**ACCESS REPORT
PROJECT APPLICATION**

CARDINAL FREEMAN VILLAGE

**137 VICTORIA STREET &
CLISSOLD, QUEEN, & SEAVIEW STREETS
ASHFIELD**

19th October 2012

Section 1.2. Residential Aged Care Facility

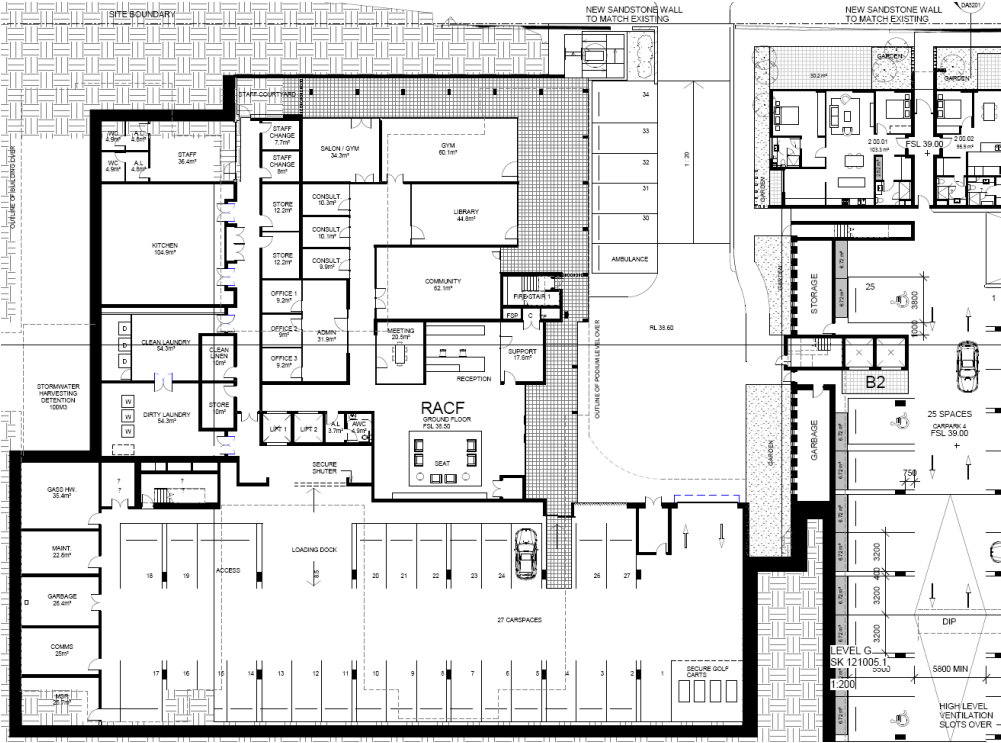
BCA Compliance	Complies
<p>I. Site Access & Pathways – The principal entrance to the Residential Aged Care Facility (RACF) at the B2 level RL39.00 shall incorporate a courtyard with direct footpath access to Clissold Street at the same level.</p> 	<p>YES</p>

BCA Compliance	Complies
<p>2. At the B1 level of RL43.00 the plans show an outdoor landscaped area adjoining the RACF building that will provide ramped accessway to the adjacent B2 building and ultimately the north-south central accessway @RL41.40, which will be detailed at construction certificate stage.</p> 	<p>YES</p>
<p>3. Building Entries – The B1 and B2 plans show the main building entries with auto-sliding doors from the adjacent pathways to enable easy access through a stepless threshold to comply with AS1428.1 and satisfy Parts D3.2 and D3.3 of the BCA.</p>	<p>YES</p>

Internal Accessways (Part D3.3 of the BCA)

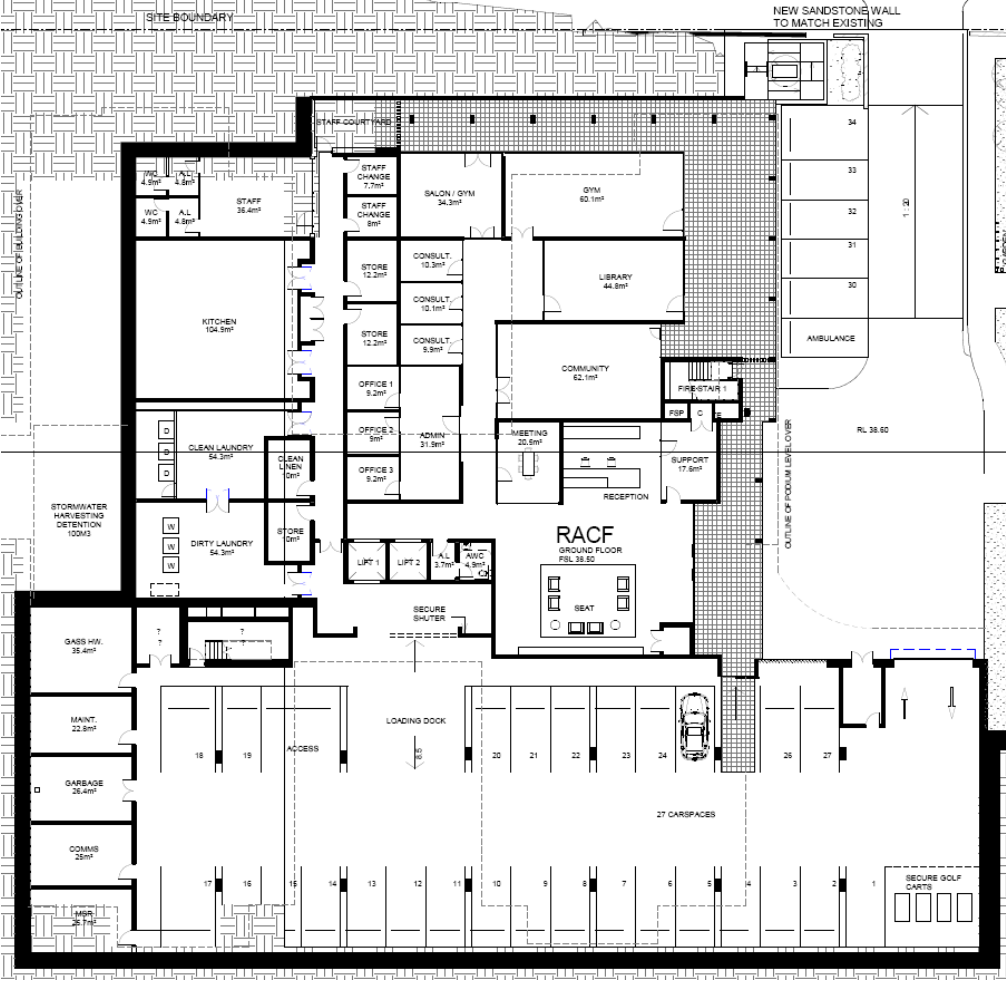
BCA Compliance	Complies
<p>8. At the B2 level (plan below) the development proposes various staff, resident communal areas and back-of house facilities in addition to the reception / lift lobby.</p> <p>9. Internal Access: B2 Level – The reception lobby provides direct access to staff admin areas and corridor to the Community Room, Medical Consulting Rooms, Library, Gym and Salon in accordance with AS1428.1 to satisfy Part D3.3 of the BCA. The Library, Community Room, Salon and Gym are also accessible from the outdoor verandah area.</p> <p>10. Other staff facilities and back-of-house utility areas are indicated on the same level and will provide appropriate access to satisfy Part D1.6(f) of the BCA.</p> 	<p>YES</p> <p>YES</p>
<p>11. Internal Access: B1 Level – The plans demonstrate lift access to this level @RL43.00 which also provides access from the outdoor accessway links to the north-south central access roadway.</p>	<p>YES</p>

BCA Compliance	Complies
 <p>12. The lift lobby lounge area provides ample circulation space that enables access to the four wings which incorporate the resident units. The double doorway to the dementia unit and central corridors to each wing provide appropriate circulation spaces to satisfy Part D1.6(f) and D3.3 of the BCA.</p> <p>13. The common dining / lounge / activity area also provides direct access to several outdoor terraces and a common unisex accessible toilet with appropriate doorway circulation spaces that will comply with ASI428.1 and hence Parts D1.6(f) and D3.3 of the BCA.</p> <p>14. Resident Suites – The resident suites indicate 1120mm doorways to enable easy access to enter rooms and comply with Part D1.6(f)(iv) of the BCA, which could be confirmed at construction certificate stage to ensure appropriate access.</p> <p>15. The development also proposes stretcher sized lifts to enable easy access to the basement and upper floors with lift landings providing a 2000mm X 2000mm+ minimum width area to facilitate ample circulation space to satisfy ASI428.1 and Part D3.3 of the BCA.</p>	<p>YES</p> <p>YES</p> <p>YES</p> <p>YES</p>

Accessible Sanitary Facilities (Part F2.4 of the BCA)

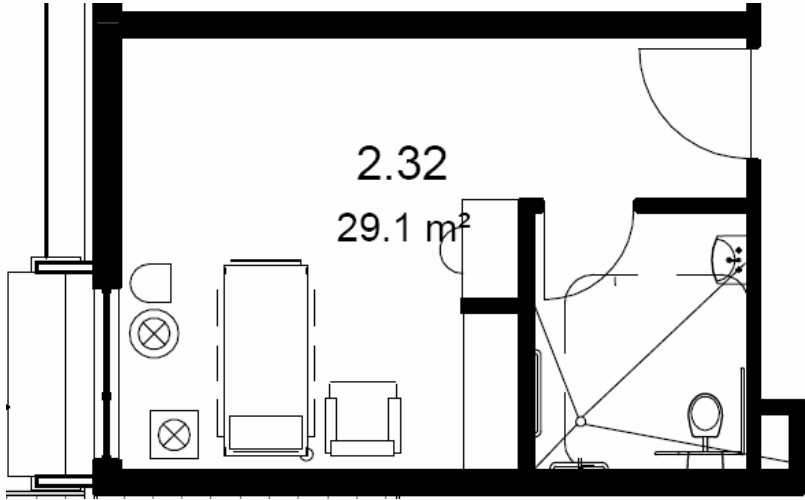
BCA Compliance	Complies
<p>21. Common Bathrooms / Visitor Toilets - The plans show five (5) common toilets one on each floor, which are all accessible as exemplified in the adjoining diagram.</p> <p>22. The adjoining plan shows an indicative unisex accessible toilet which provides an area of 2200mm X 2000mm and subject to the detailing of the doorway and installation of accessible fittings in accordance with AS1428.1 the facility will comply with Part F2.4 of the BCA.</p>	 <p>YES</p>

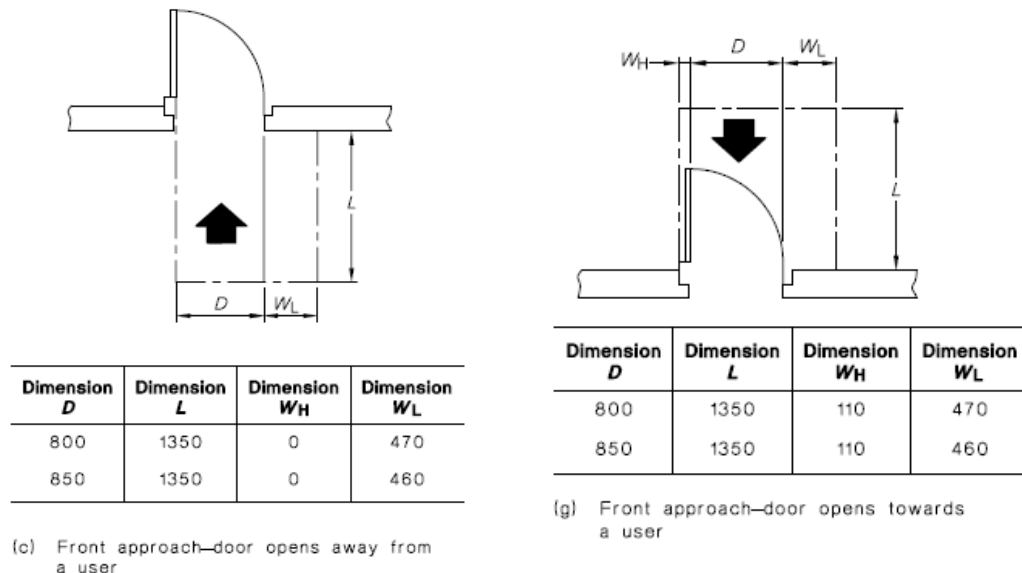
Where corridors provide side-on approaches to doors the doorway circulation spaces require 1160mm minimum width in accordance with **YES at**
 Figure 12(a)(b) of AS1428.1 to satisfy clause 7 of schedule 3, which can **CC**
 be detailed at construction certificate stage. **stage**

Where front-on approaches to doorways are provided then the doorway circulation spaces shall provide at least 1450mm width with 470mm minimum latch side clearance in accordance with Figure 12(c)(g) of ASI428.1 to satisfy clause 7 of schedule 3.

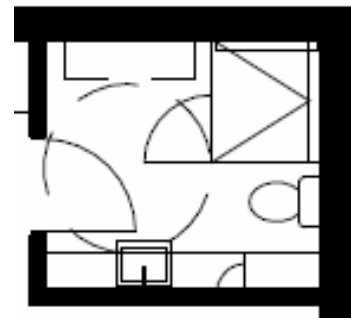
Schedule 3
Clause 9 **Bathroom** – The plans show an ensuite or a bathroom in every unit will provide the spatial area and layout that complies with AS4299/1428.1 providing the following dimensions – 2300 X 2550.

While the layouts of fittings are consistent with ASI428.1 the construction certificate drawings shall confirm the following in accordance with ASI428.1:

- Toilet in a recessed corner to enable retrofitting of grabrails and provide 1200mm clearance in front of the pan,
- Vanity washbasin that will have plumbing that can be adapted to comply with ASI428.1.
- 1160mm X 1100mm minimum shower area with 1400mm X 1600mm minimum circulation area and a removable screen that can accommodate a grabrail, folding seat and portable shower head to comply with ASI428.1.
- Wall cabinet and mirror with an adjoining power outlet 600-1100mm height above the floor in accordance with AS4299 and the SEPP HS.

SEPP HS **Site Access – Wheelchair Access**

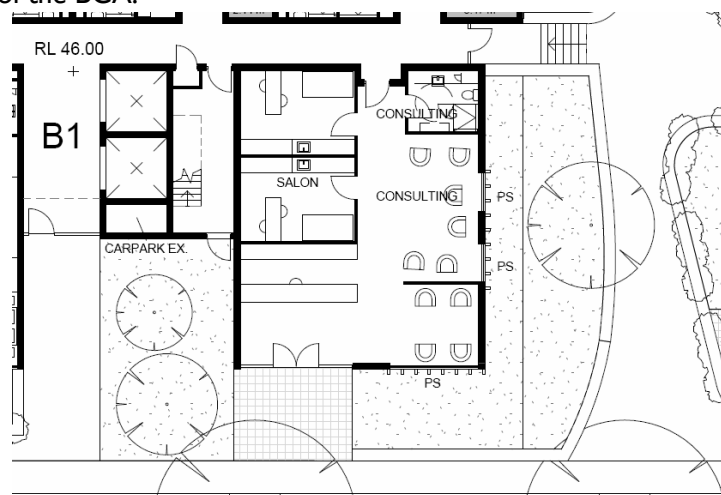
Schedule 3, Clause 2(1)(2) A review of the plans indicates access routes along the realigned east-west roadway from Queen Street to Victoria Street shall facilitate accessible paths of travel to Buildings B1 and B4, which enables access to the Chapel in a manner that will comply with ASI428.1 and thereby satisfy schedule 3 clause 2(1) of the SEPP HS.
